SERVICE BULLETIN

from: TRIO-KENWOOD COMMUNICATIONS, INC.

TS-180

SUBJECT: TS-180 VFO STABILITY

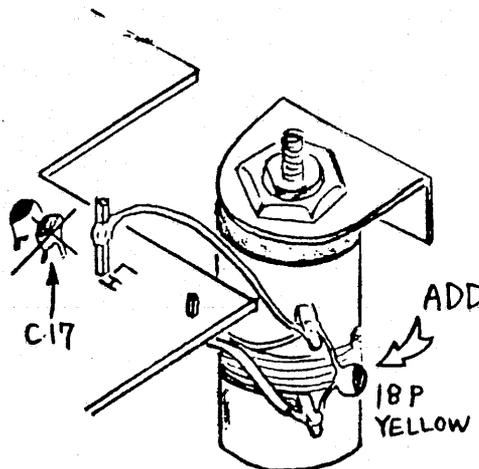
VFO drift characteristic may be improved by changing a capacitor value and location in the VFO.

1. Begin by calibrating the analog dial to the Digital Display at 14.000.0MHz. DO NOT disturb this calibration while working on the VFO.
2. Turn off the main power and remove the VFO unit by two 3mm hex head bolts.
3. Withdraw out the front panel and unplug the leads.
4. Remove the VFO cover by five Phillips head screws.
5. Remove C17 from the PCB. This may be cut flush to the board.
6. Install the 18pF yellow cap across the tank coil terminals. Position the cap near the coil.
7. To reassemble, perform steps 3,2. Snug all VFO case screws. A later complaint of frequency jump would indicate a loose VFO shell.
8. Turn on the radio and check analog dial calibration against the Digital Display. Adjust VC1 (center of the Seal Tape) only if the zero-point has moved.
9. VFO linearity final check: The Digital readout and analog dial should agree to within ± 2 KHz at every 100 KHz dial point.

New Part: 18pF CC45RG1H180J
Old Part: 18pF CC45PG1H180J
